HORSHAM DISTRICT COUNCIL CONSULTATION

TO:	Horsham District Council – Planning Dept
LOCATION:	Mowbray Development Site Land North of Horsham Rusper Road Horsham
DESCRIPTION:	Application for approval of Reserved Matters (access, appearance, landscaping, layout and scale) pursuant to Condition 5 of Outline Planning Permission reference DC/16/1677 for RM Areas 5 and 6 comprising 206 (C3 Use) residential units, car and cycle parking, new landscaping, drainage, access and internal roads, and associated infrastructure.
REFERENCE:	DC/24/1927
RECOMMENDATION:	Modification

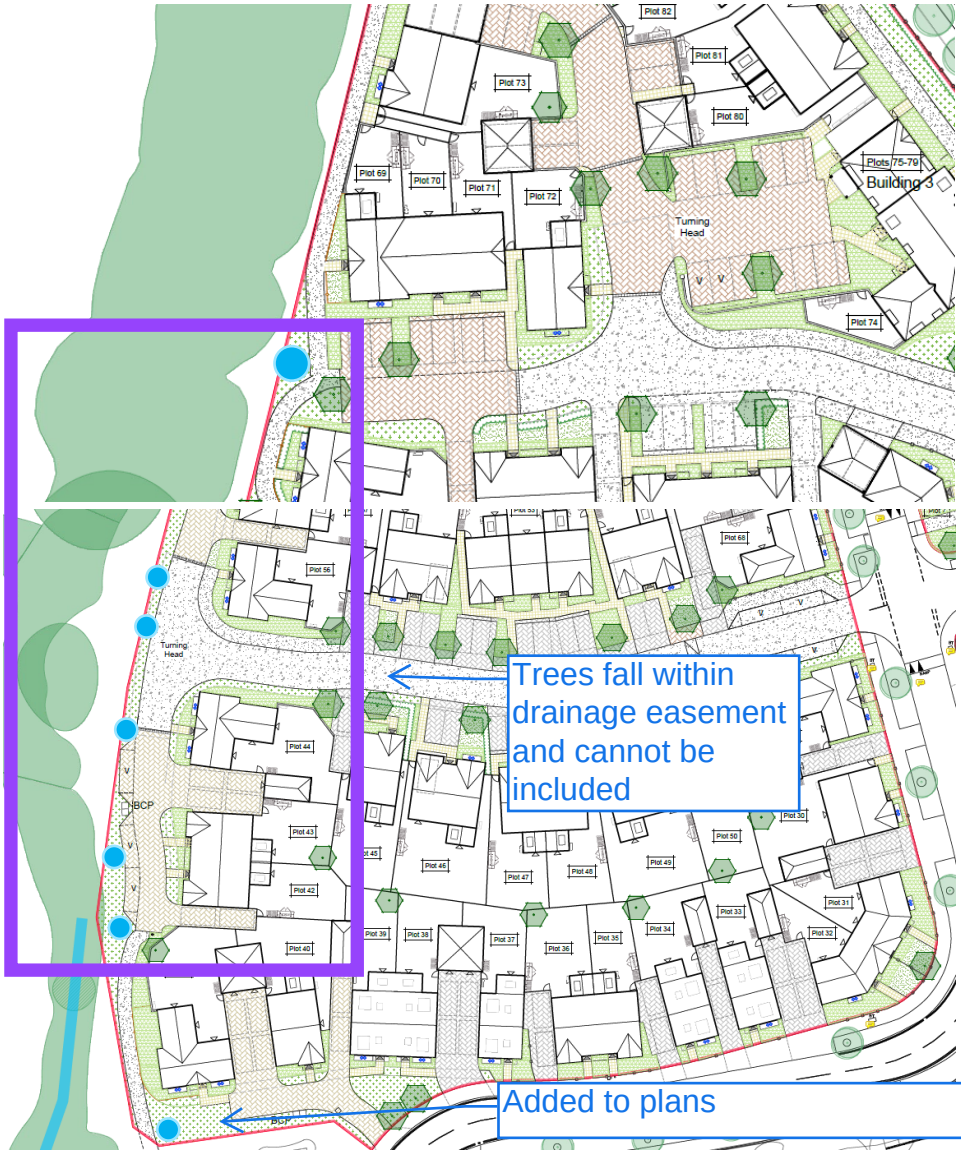
1. 1no. Heavy standard tree is requested (as indicated in blue, below) in order to provide a designed sense of arrival and a softer approach into the RM5 area.

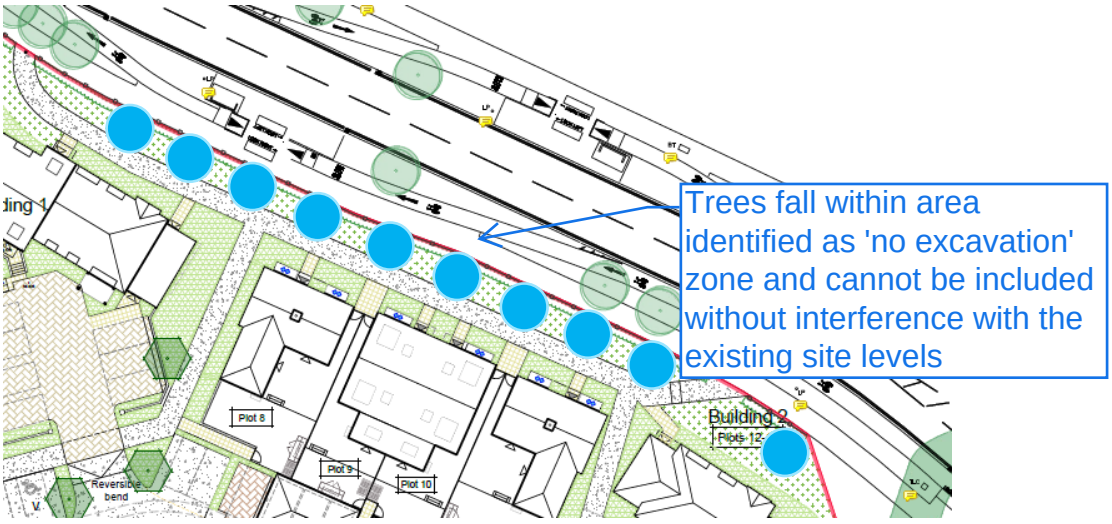
2. While no existing trees and hedgerow lie within the red line boundary (RLB), as stated within the Design Compliance statement, they should be strengthened with new planting where possible. Please see suggestions (as indicated in blue, below) to strengthen the existing trees and hedgerow on the western boundary, and as above, to provide a softer approach into the RM5 area.

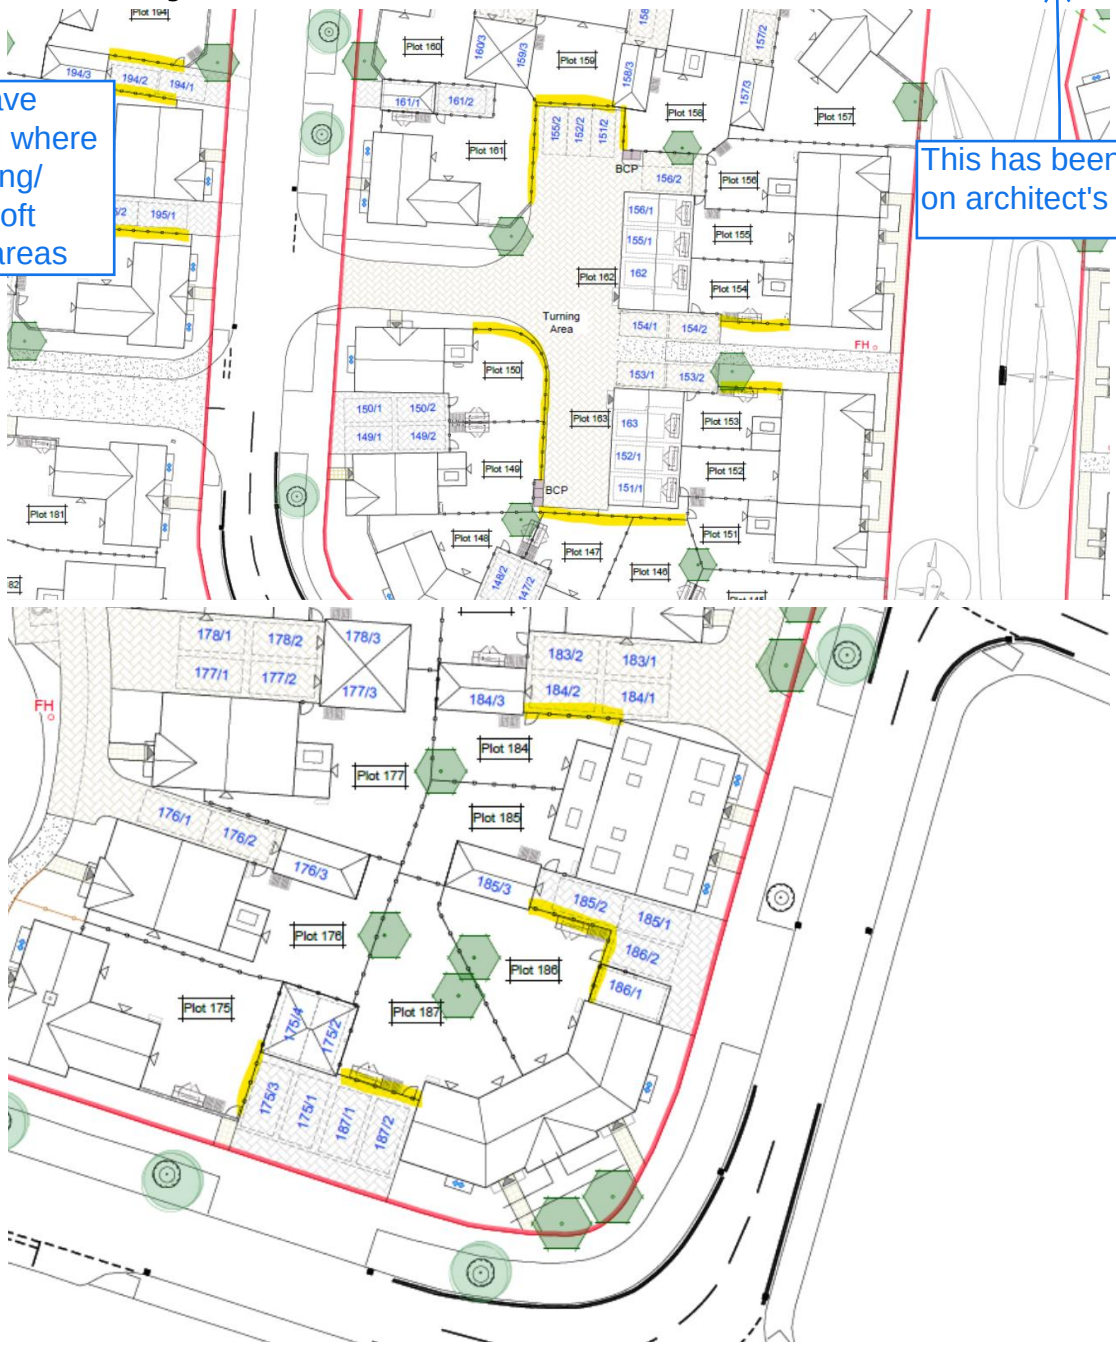
3. In order to ensure a high quality environment, where visible and where abutting the public realm, we recommend implementing brick walls and planting for garden boundary treatments.
    a. Where this is not possible, we expect to see provision of details of high quality timber fencing.
    b. Climber planting should be provided alongside boundary treatments, particularly where they face onto the roads, pathways, public open space and other key locations within the public realm.
    c. See suggestions (highlighted in yellow, below) for locations where close board fencing should be amended to the above.

Climbers have been added where timber fencing/ walls abut soft landscape areas

This has been updated on architect's proposals

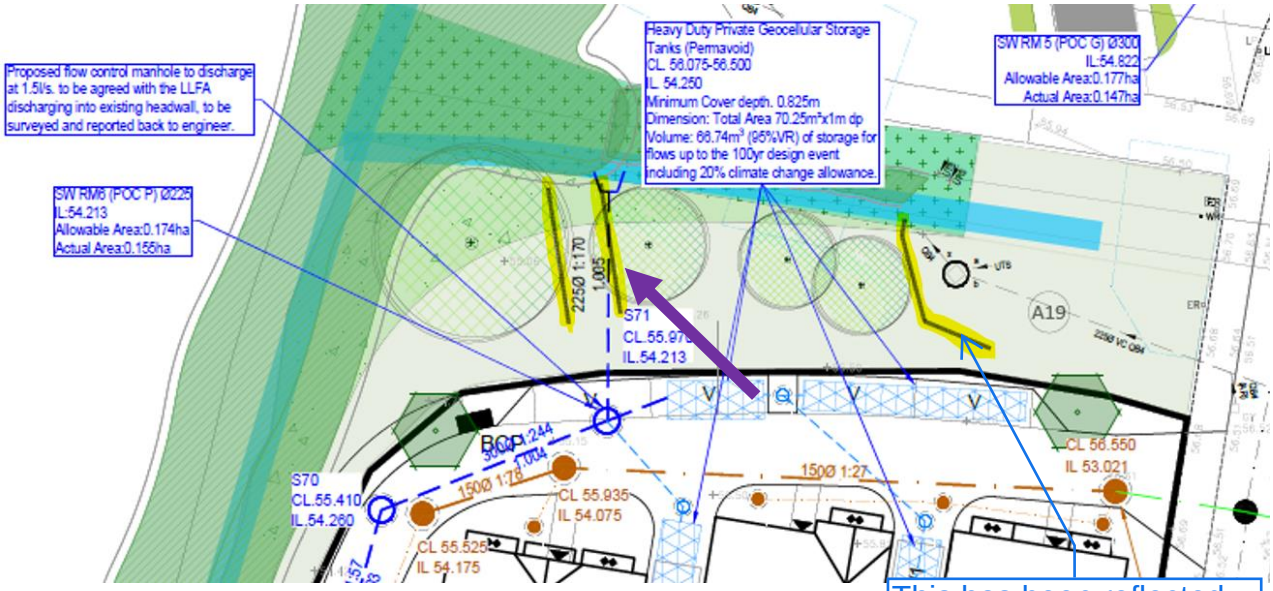
4. Clarification is requested in regard to the grey lines (highlighted in yellow, below) which appear to not correlate with proposed drainage.

This has been reflected on the engineer's plans
